FORT CALHOUN
TECHNICAL
SPECIFICATIONS

DISCUSSION

The proposed license change is submitted to:

FIGURE
5-1

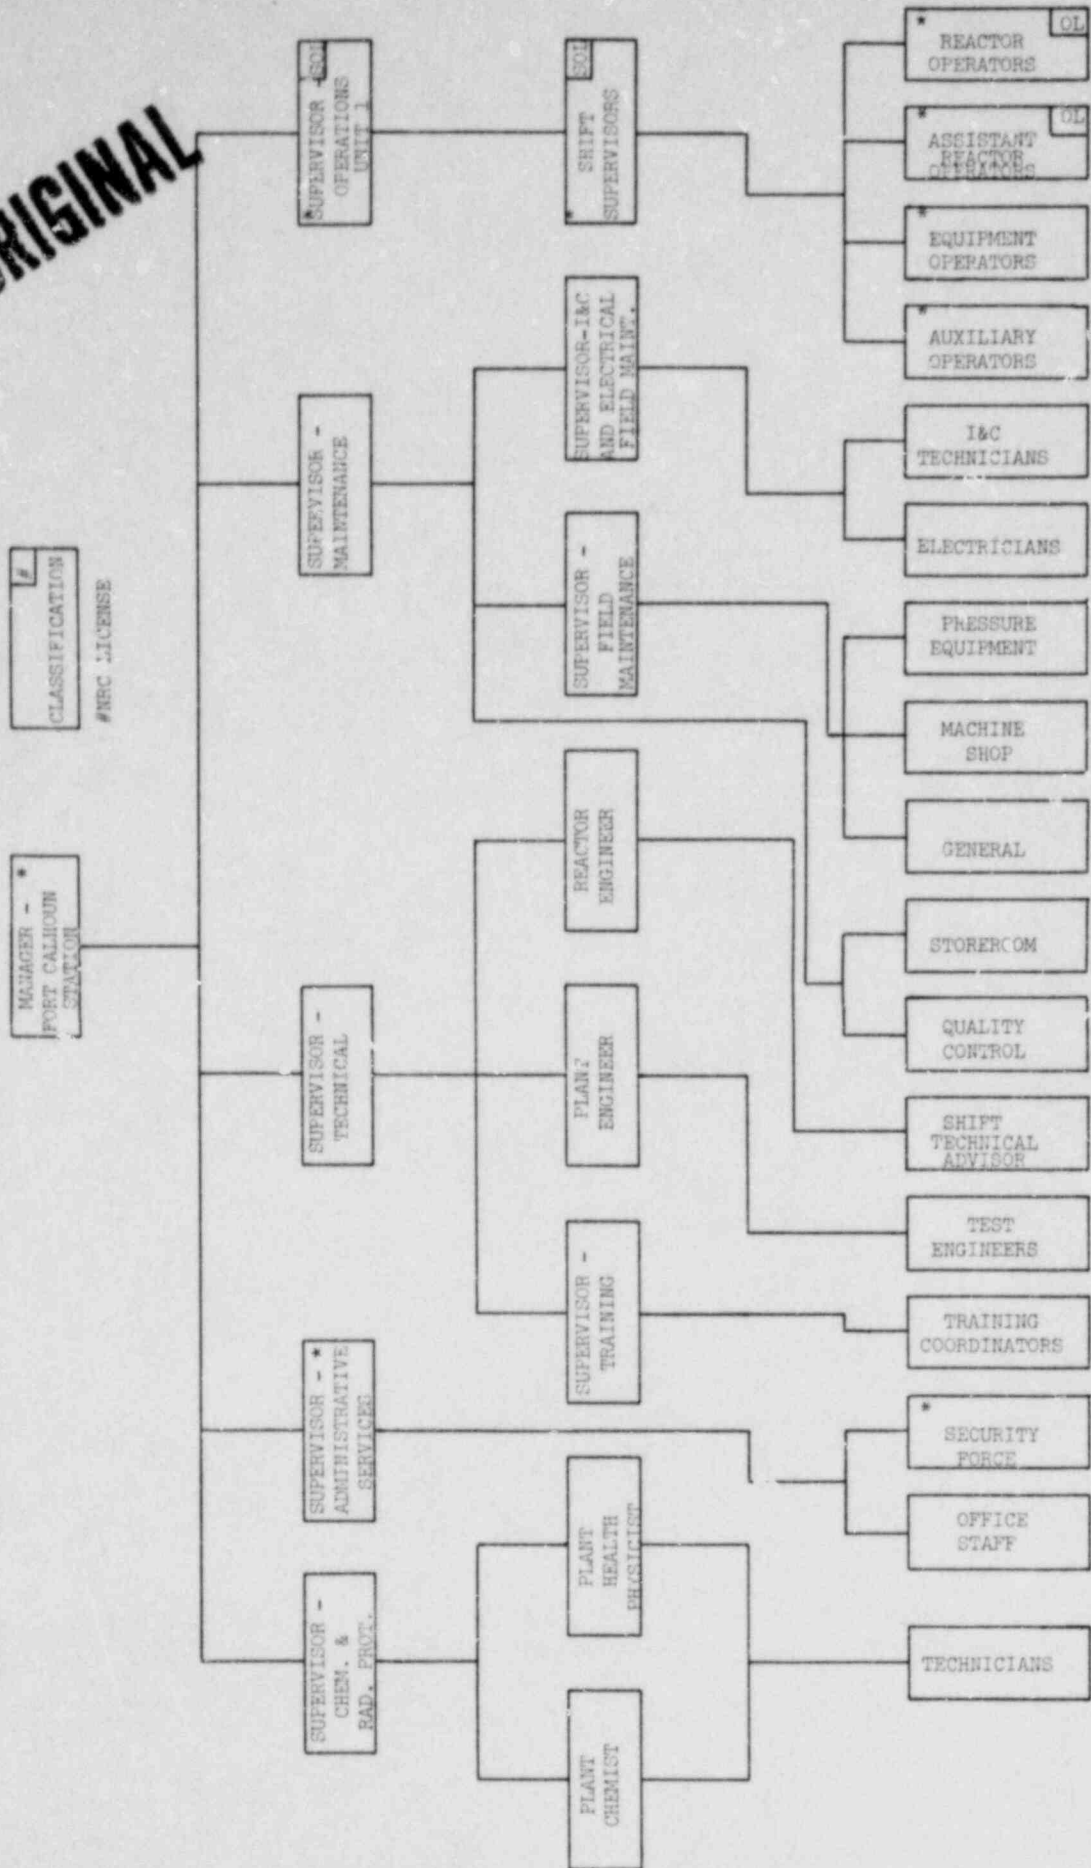
Organizational Charts. The District's Staff Support organizational charts (Figures 5-1, 5-1A, and 5-2) have been revised to reflect the District's current organization. Figure 5-1A has been deleted.
